WATER RESOURCES DEPARTMENT

Date: July 6, 2017TO: Application: G18497FROM: GW: Aurora Bouchier
(Reviewer's Name)SUBJECT: Scenic Waterway Interference & General/Local Surface Water
Evaluation for Deschutes Ground Water Study AreaThe source of appropriation is within or above the Deschutes
Scenic Waterway.

TO: Water Rights Section Date July 6, 2017
 FROM: Groundwater Section Aurora C Bouchier
 SUBJECT: Application G- 18497 Supersedes review of na
 Reviewer's Name
 Date of Review(s)

Water-Level Trend at DESC 2929 and Cumulative Departure at Sisters

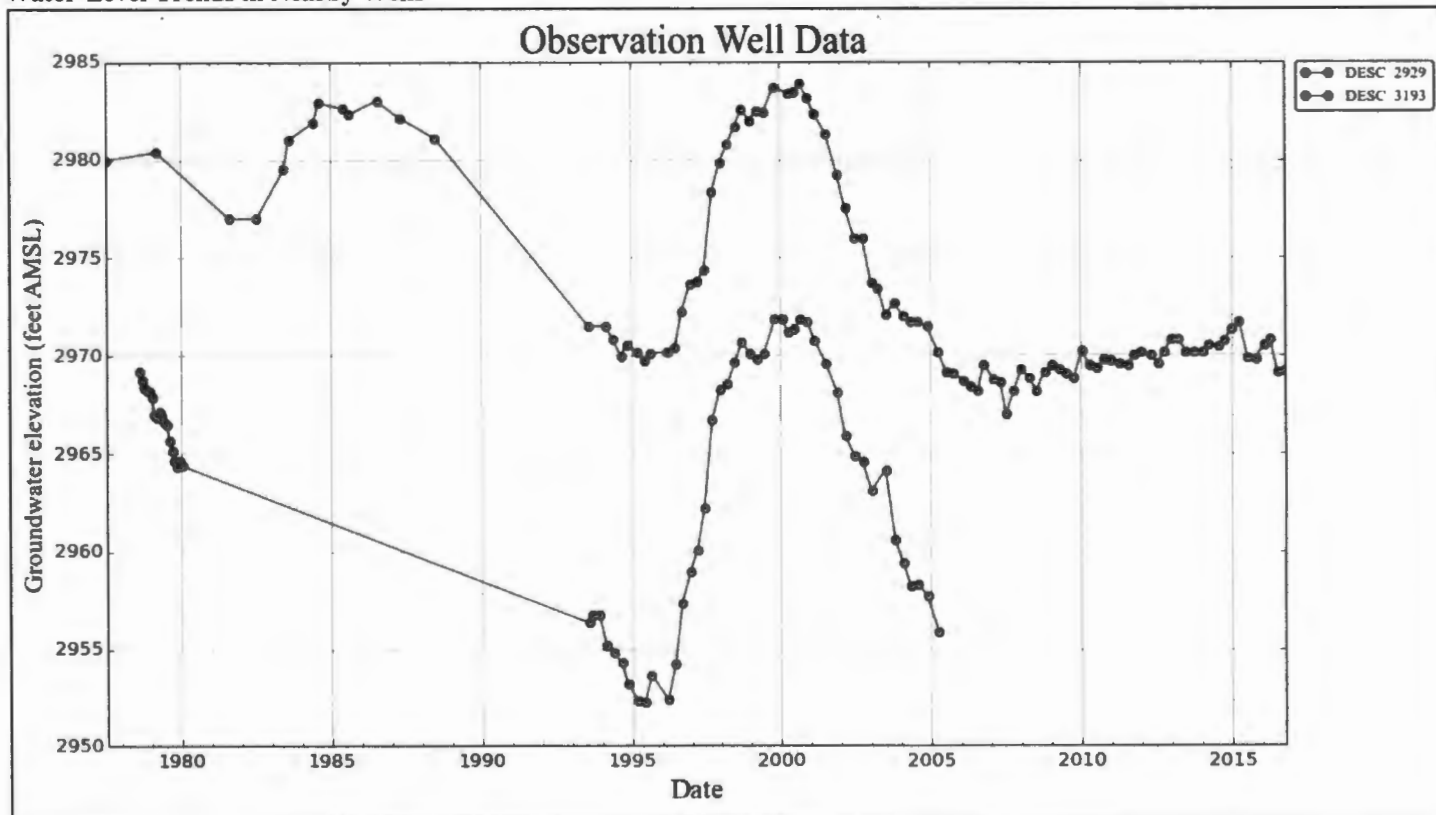
The nearest State Observation Well (DESC 3193) is located approximately 1.7 miles to the west-northwest, unfortunately measurements at this well ceased in 2005. The nearest State Observation Well currently being measured (DESC 2929) is located approximately 5.7 miles to the northwest. During the periods of overlap, the hydrograph of the wells shows a similar pattern. The long-term trend shows a decadal-scale water level fluctuation that appears coincident with local climate cycles. The decadal fluctuation has a maximum amplitude of approximately 15-feet.
